July 19, 2001

Pratt & Whitney  
UTC 9901-72081  
R-9  
RDMS # 100156

**RE: General Permit for Discharge of Stormwater &  
Dewatering Wastewater from Construction Activities  
Willow Brook and Willow Brook Pond, PCB Remediation Project  
East Hartford, Connecticut**

FIGURE 2-6

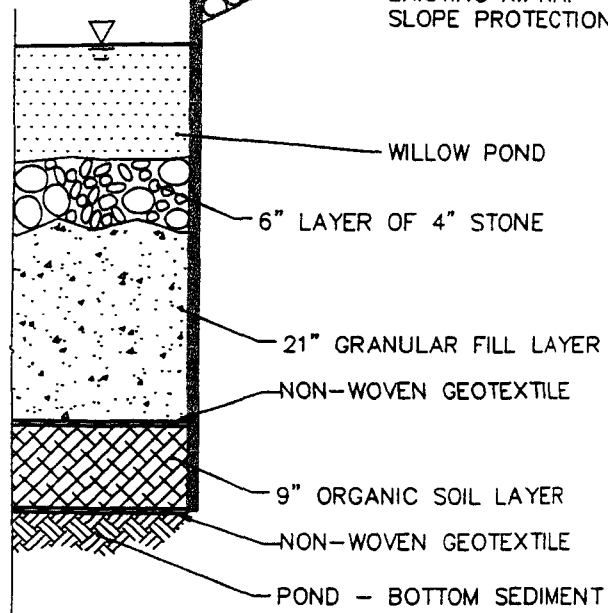
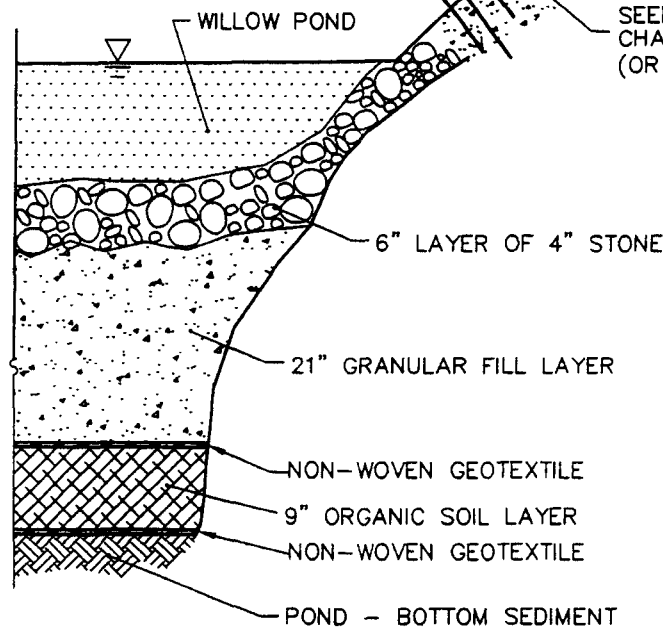
I would like to thank you for taking the time to expedite review of our General Permit registration for the above referenced project. Loureiro Engineering Associates, Inc. (LEA) has prepared this letter on behalf of our client, United Technologies Corporation, Pratt & Whitney Division (UTC/P&W), to provide a response to your concern regarding the suspension of fines upon reinitiating flow within Willow Brook Pond.

As presented during our meeting, the flow from Willow Brook will be diverted through a temporary bypass channel to facilitate the necessary remedial activities within Willow Brook and Willow Brook Pond. Upon completion of the remedial excavation, the ponds (upper and lower) will be capped with a 3-foot thick cap (Attachment 1) consisting of two separate geo-synthetic fabrics, an organic layer, granular fill all topped with a 6-inch course of 4-inch stone (armor). This armor will extend throughout the entire bottom of the ponds up to the ordinary water level or existing pond sidewall structures (riprap, sheet piles, etc.).

The armor layer will consist of screened material from a stone crushing operation. The intent of this material is to offer a sound well bound armor layer offering erosion protection for the underlying cap materials. As such, the gradation specification for the selected material will not include provision for any fines. This material typically arrives on-site well washed and relatively dust free. The material will be temporarily stockpiled on-site prior to placement, inspected for the presence of fines and washed with pressurized water if necessary. Consequently, we do not expect significant sedimentation suspension upon reinitiating the flow. Any rinseate generated during the washing activities will be handled in accordance with our site specific SWPPP.

**Attachment 2**  
**Detail – Florida Diaper**

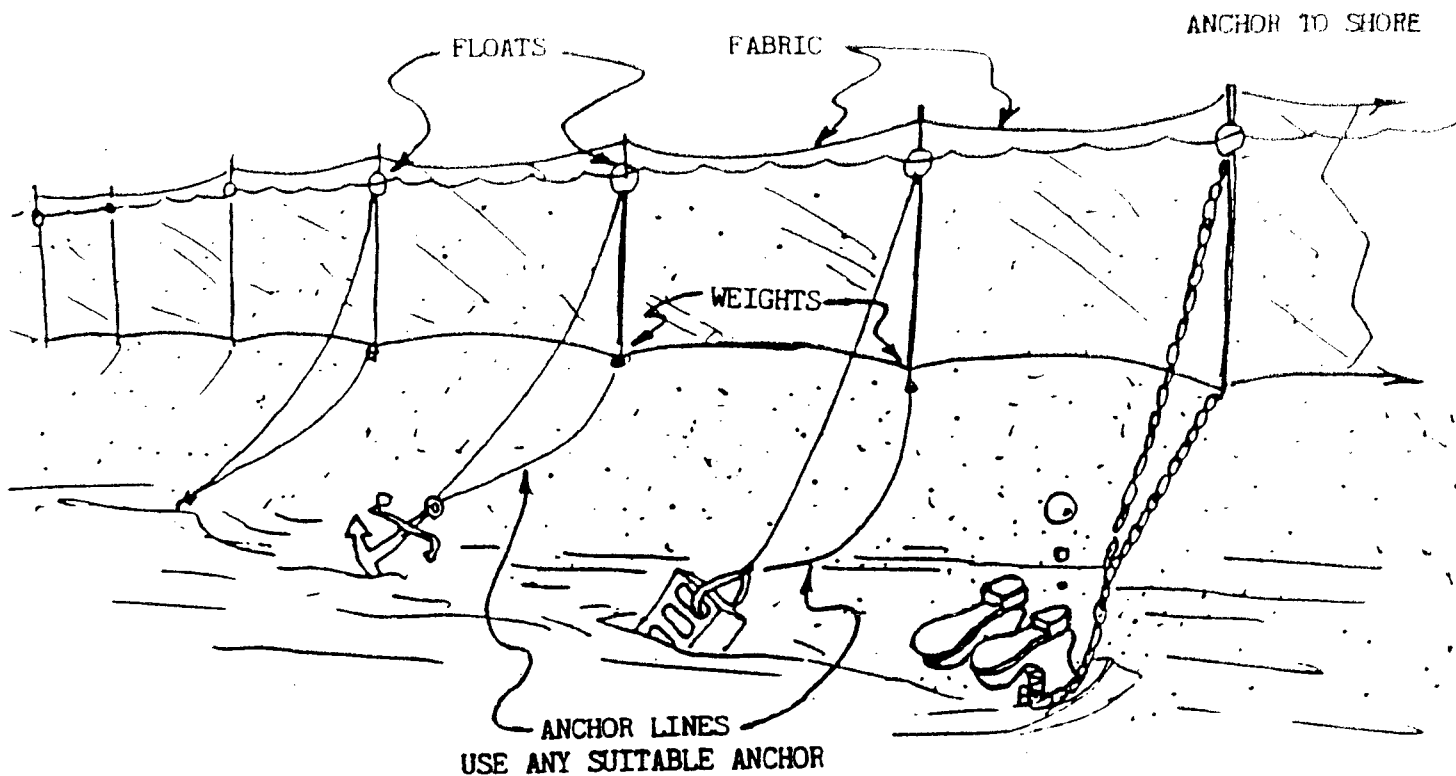
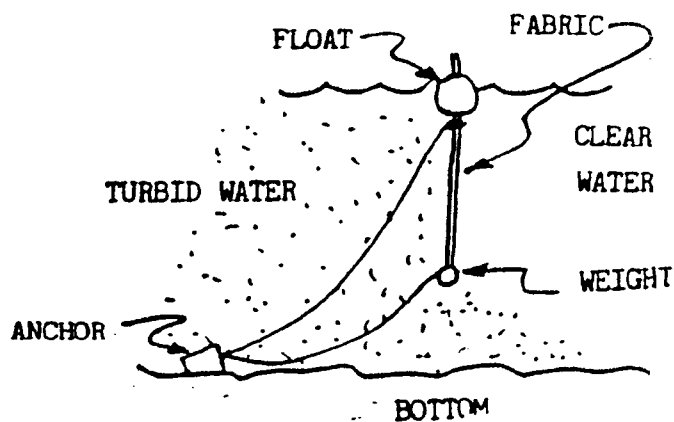
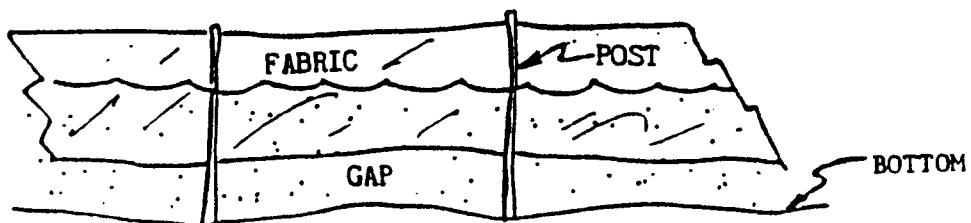
Since clean stone will be used as armor for the cap surface, very little suspended sediment will be generated. The above-described measures will be adequate to address the concern that sediment will be suspended in the water column upon reinitiation of the flow. However, if our initial assessment of the "refilling" activities suggests that more aggressive measures are appropriate, we will be equipped to immediately install a fixed or floating diaper (a.k.a. Florida Diaper) across the upstream side of the dam as a contingency. A typical detail of this installation is provided as Attachment 2.
